Symmetry Park, Knowsley, Merseyside

Response to Knowsley Council Highways Comments

VN212041

DRAWING NUMBER: VN81193-D114

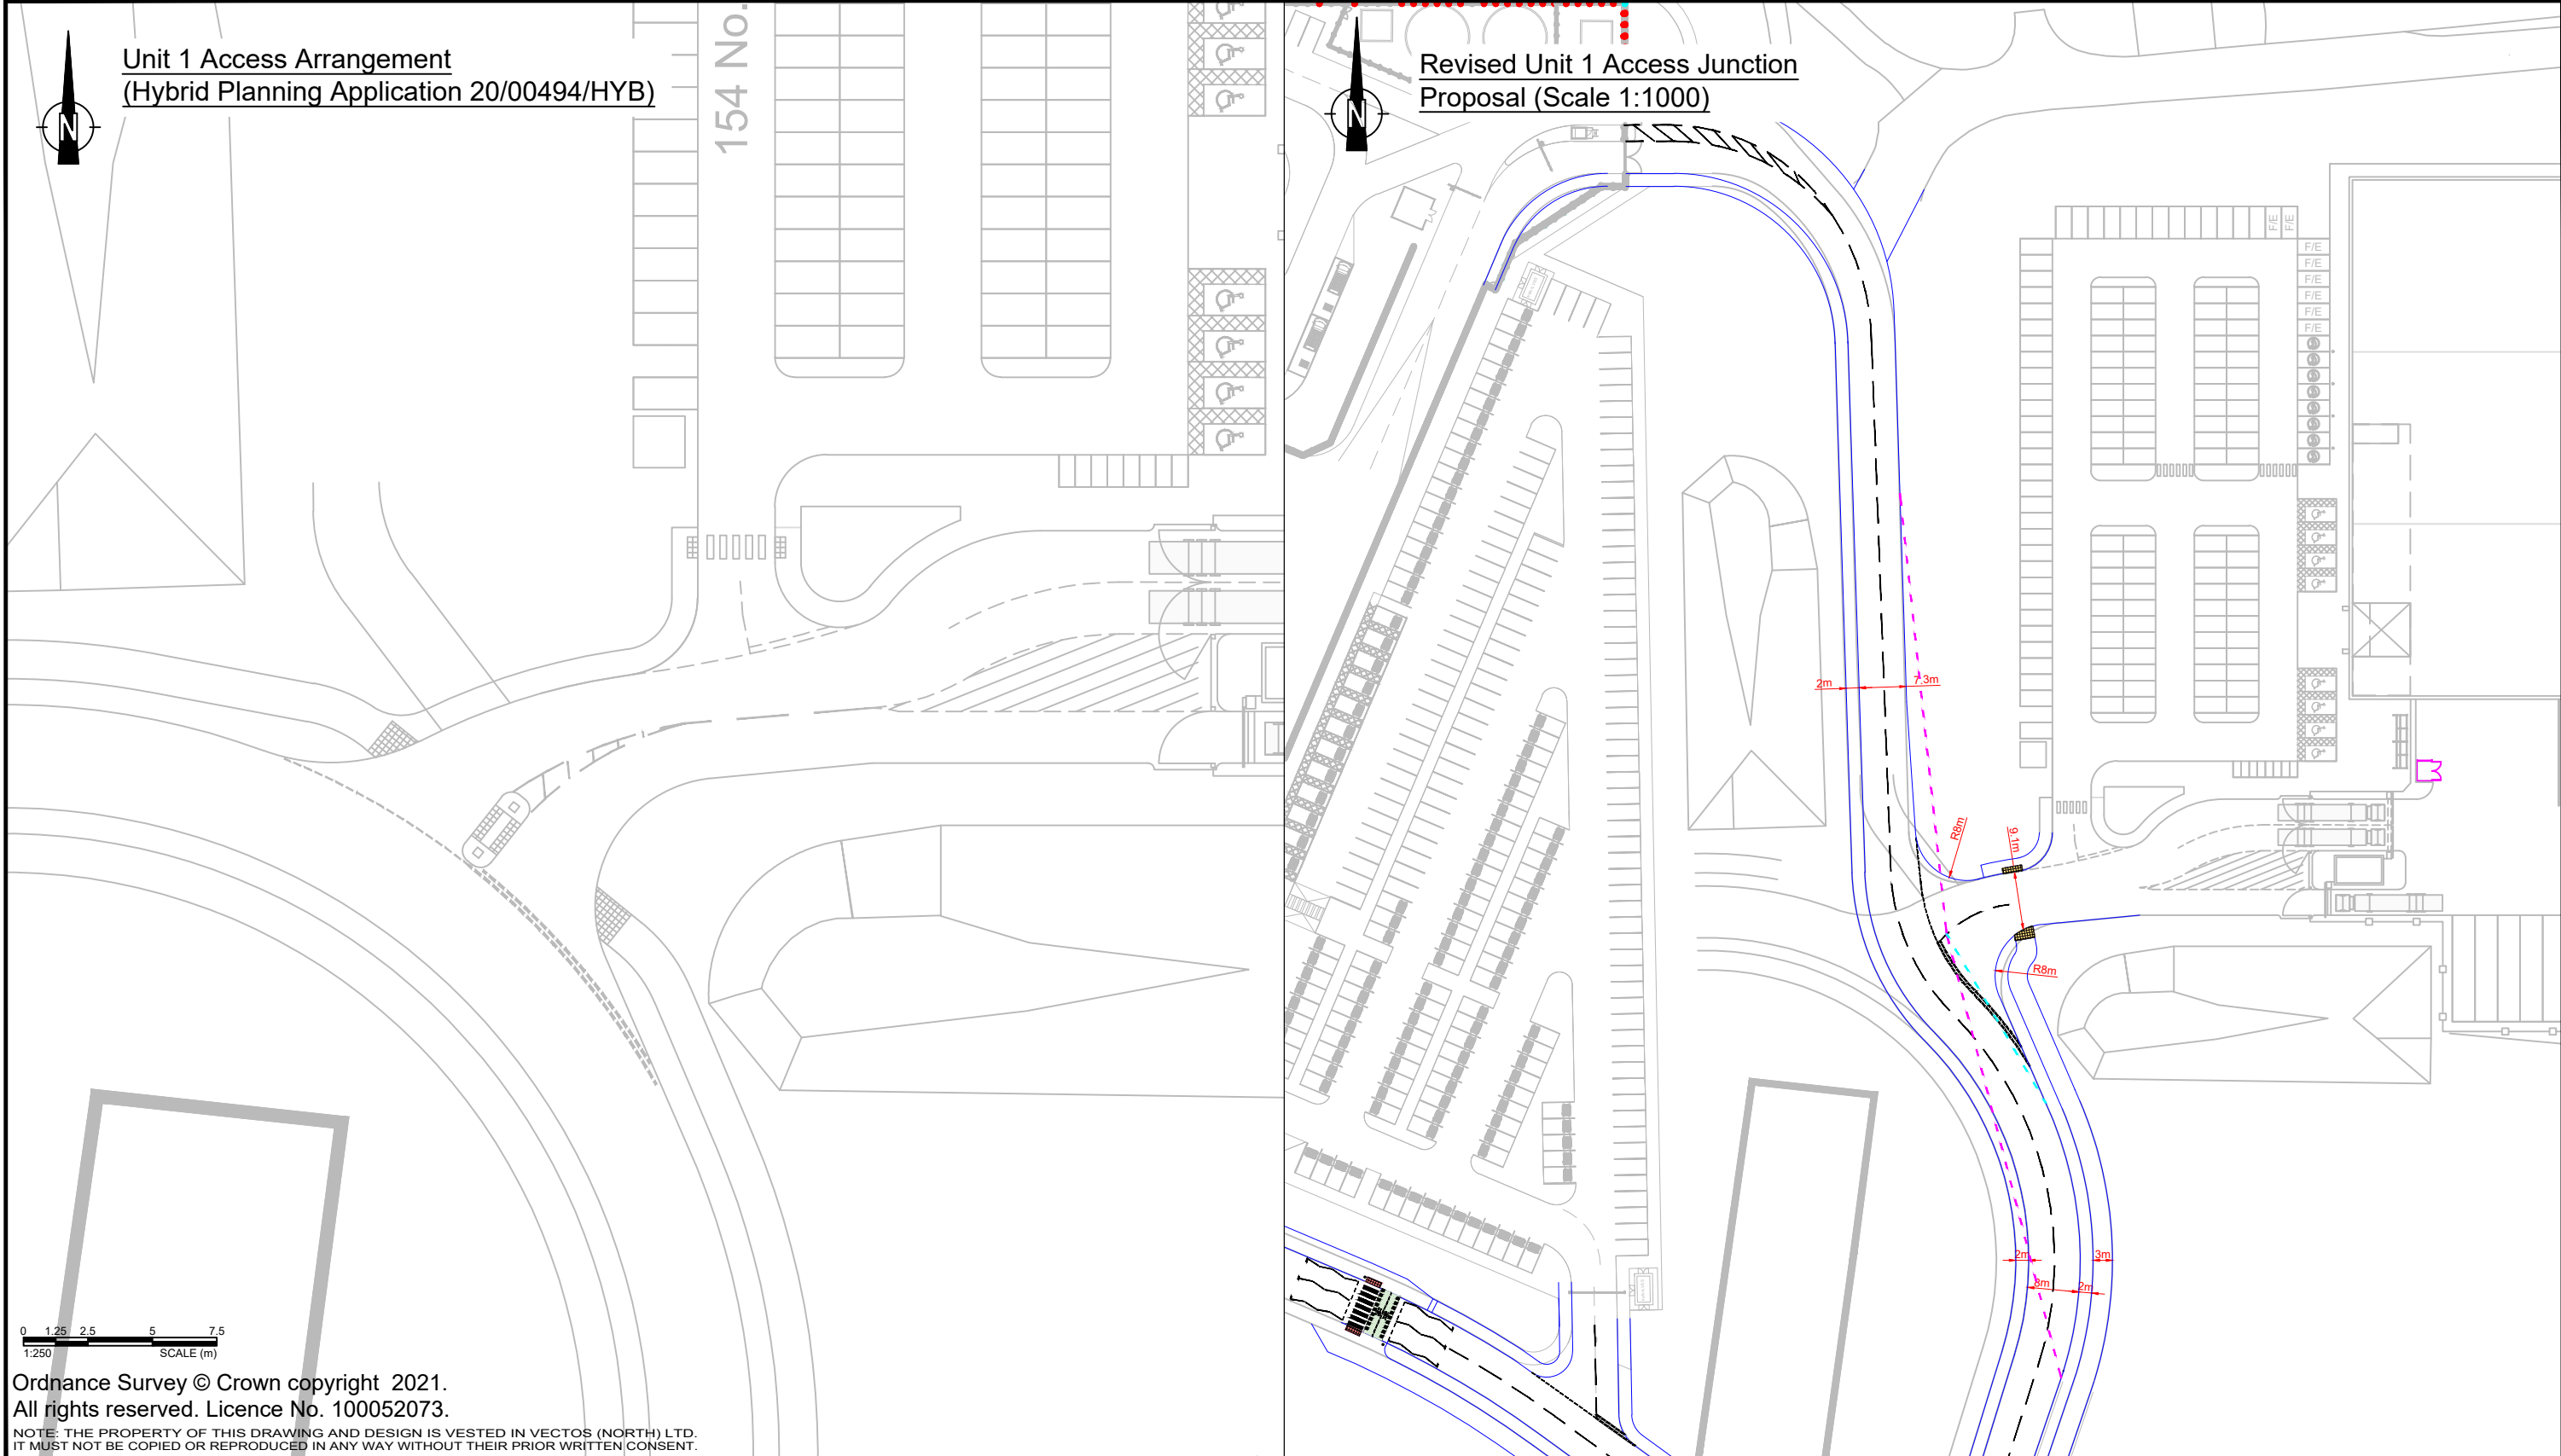
The Unit 1 access (previously approved) has been amended slightly. A Non-Material Amendment application is expected to be submitted for this shortly. The access will be reviewed then, although it should be noted that the access is not ideal in its current form. The access does not meet perpendicular with the internal carriageway and drivers will likely need to crane their necks to check for vehicles travelling south.

14. The Non-Material Amendment (NMA) application was submitted to the Council on 11/03/2022 (reference: 20/00494/NMA) and that provides the detail relating to the changes to the Unit 1 access. The proposed amendment to the Unit 1 access is shown in **Drawing VN81193-D114 Rev A**. This shows the previously approved Unit 1 access layout and the proposed revised layout. Visibility splays have been shown on the proposed layout and this demonstrates that suitable visibility of 2.4m x 70m in either direction along the north-south internal site access road can be provided at the revised Unit 1 access junction. The amended access also provides improved facilities for cyclists and pedestrians, removing the need to cross the access at the widest point, and the emergency access into the site is proposed to be on the internal access road further north away from the Unit 1 access junction.

DRAWING NUMBER:	REVISION:
VN212041-TR103	E

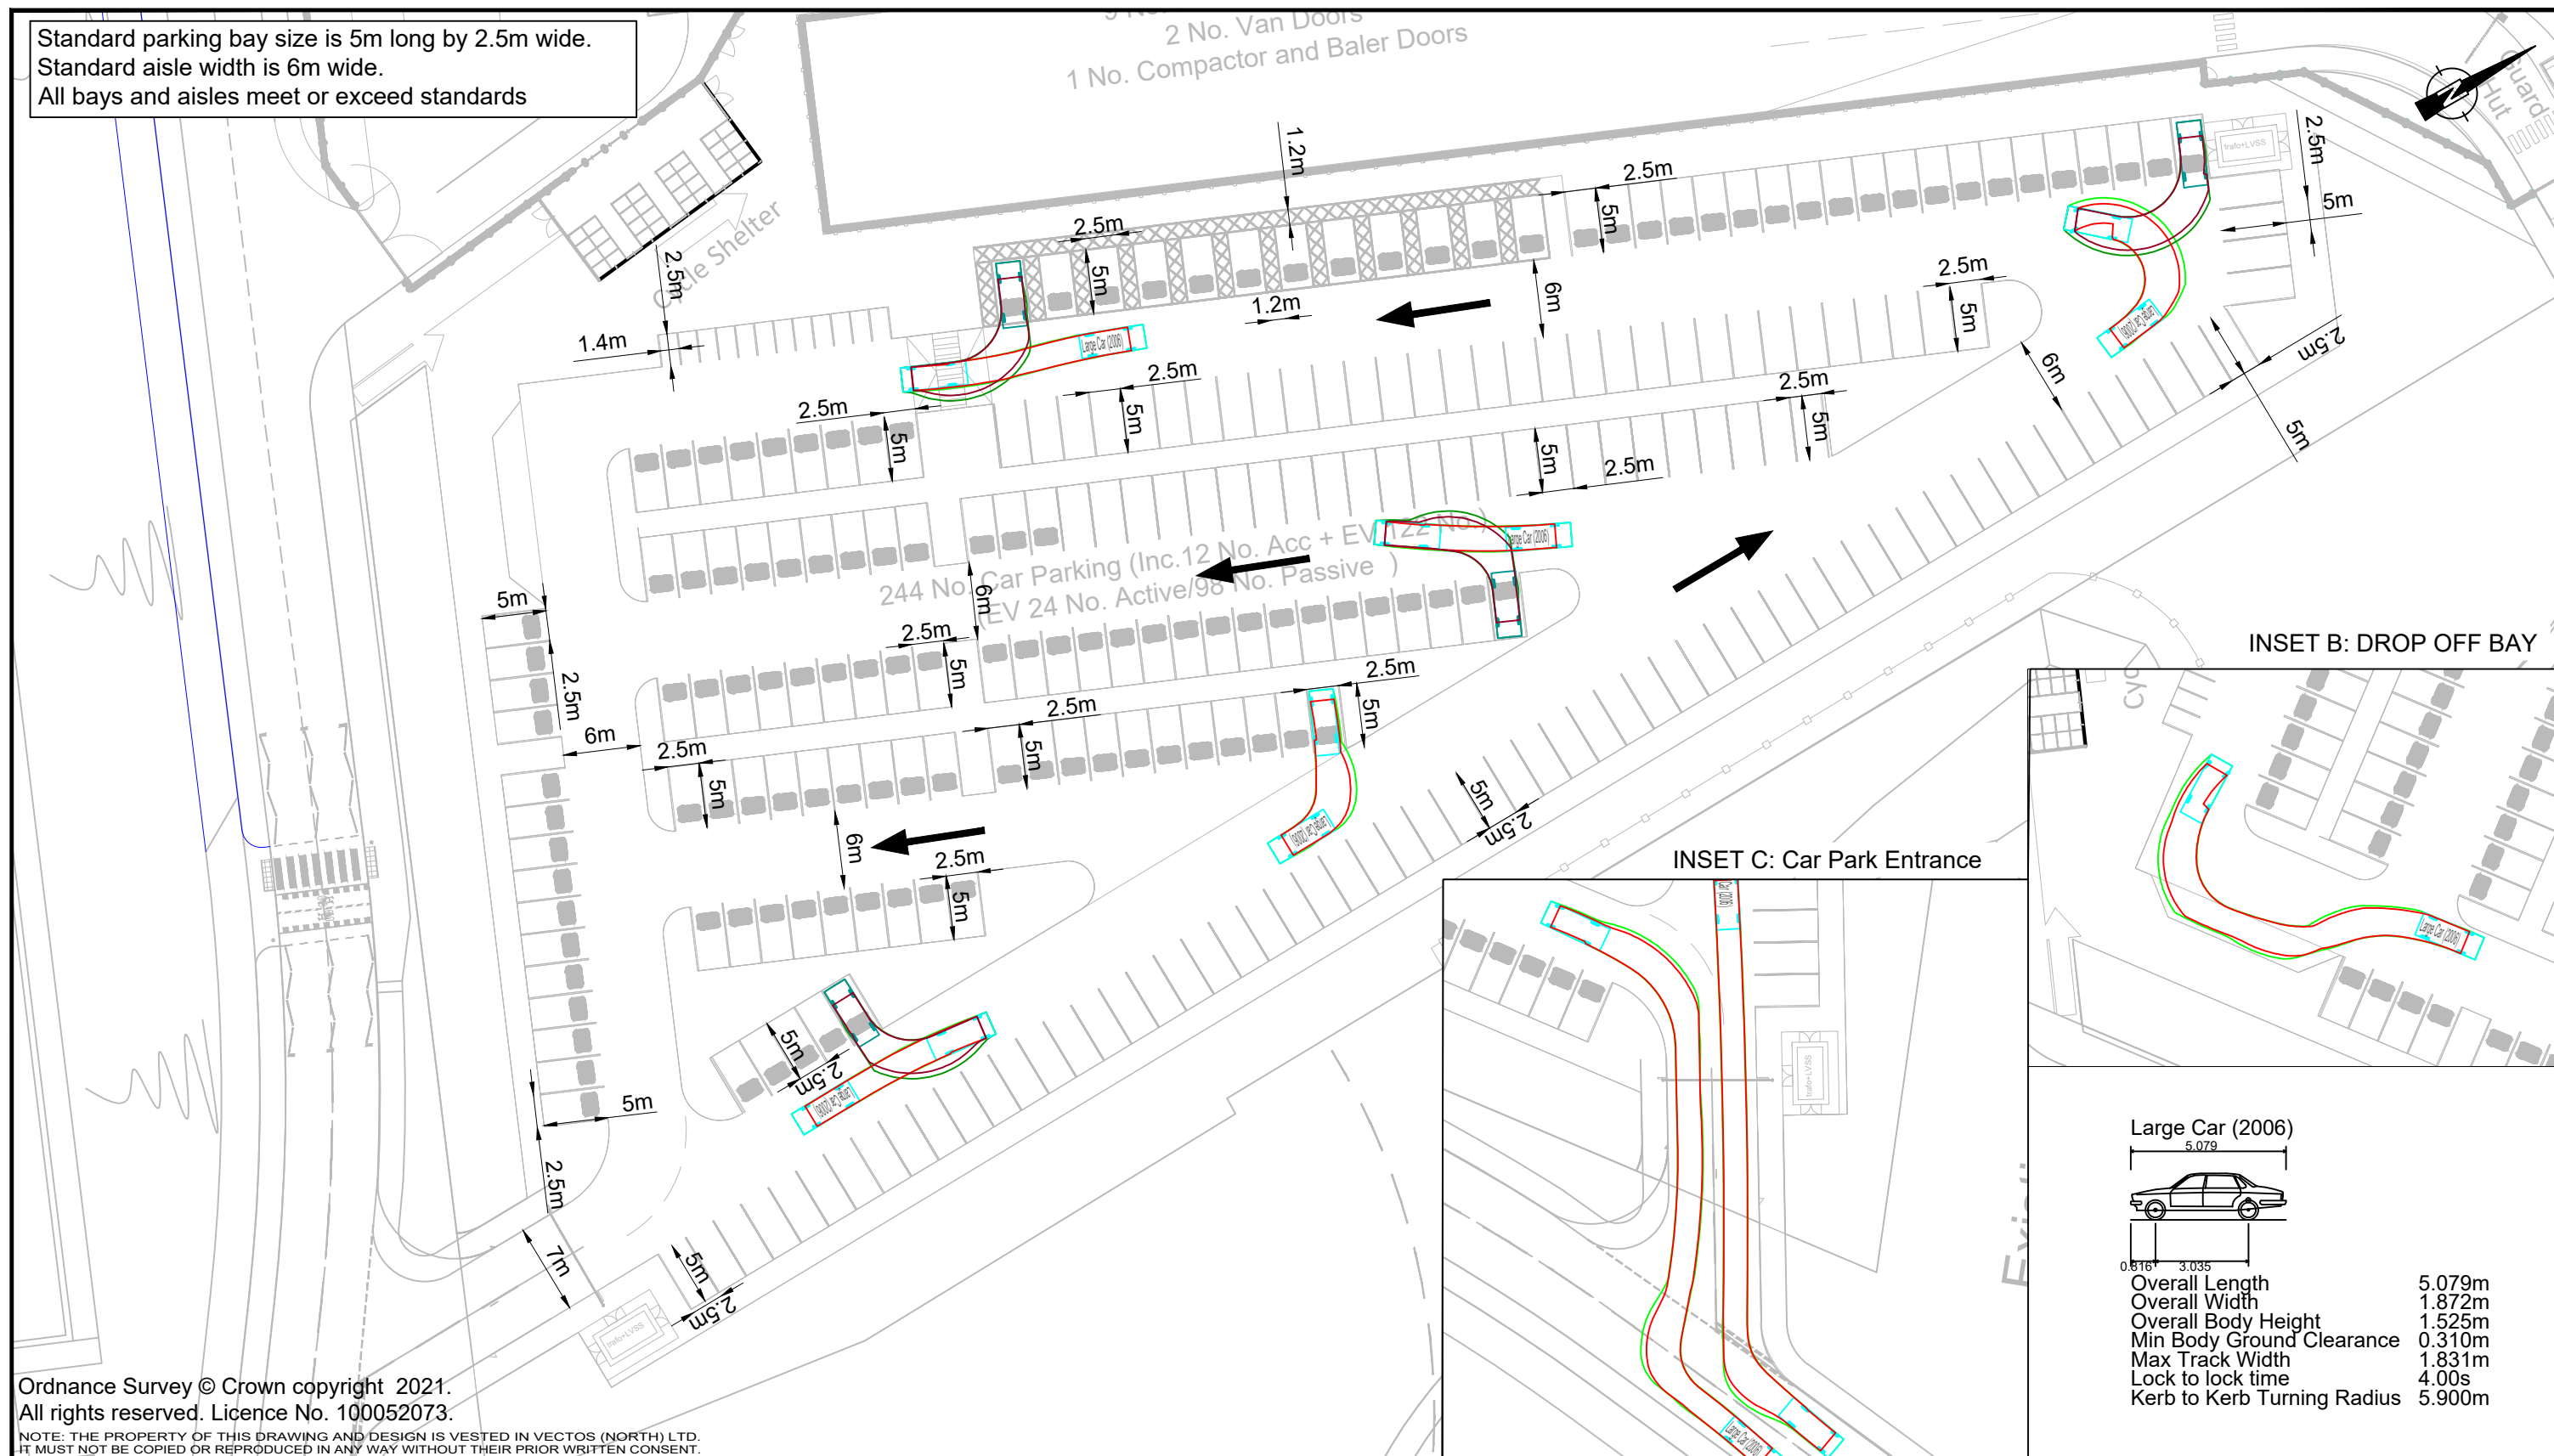
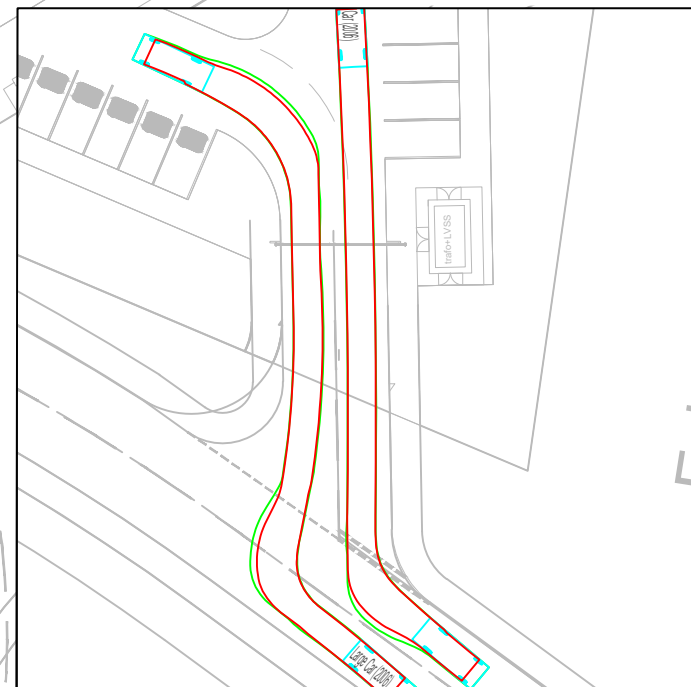
No swept path has been provided for the site access itself. The vehicle used is also only 4.8m long, whereas a 5.0m length vehicle should be used. The car park will need the swept path assessment completing again with a 5.0m length car, with the access also assessed.

9. The updated swept path assessment is shown in **Drawing VN212041-TR103 E.**
